## Changes of the external appearance of the terminal block cover of MELSEC iQ-F series FX5U CPU module

June 2019

MELSEC iQ-F series FX5U CPU module

HIME-T-P-0203A

Changed Items: Terminal block cover of FX5U CPU module	
Before change	
After change	 <p>Notches are added. (2 places both in right and left, 4 places in total)</p>

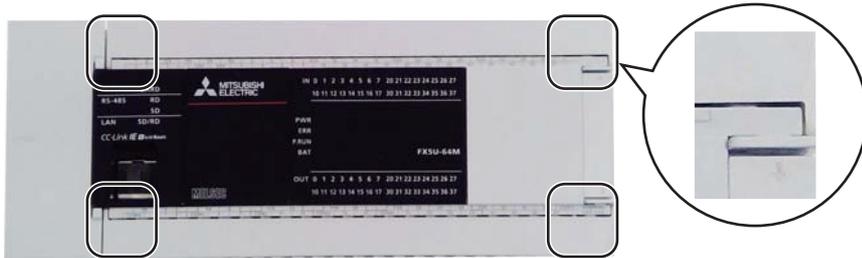
To improve the fitting property of the terminal block cover of FX5U CPU module, the design will be changed.

Due to this change, the external appearance of the terminal block cover will also be changed.

The external appearance of the terminal block cover of FX5U CPU module is changed as below.
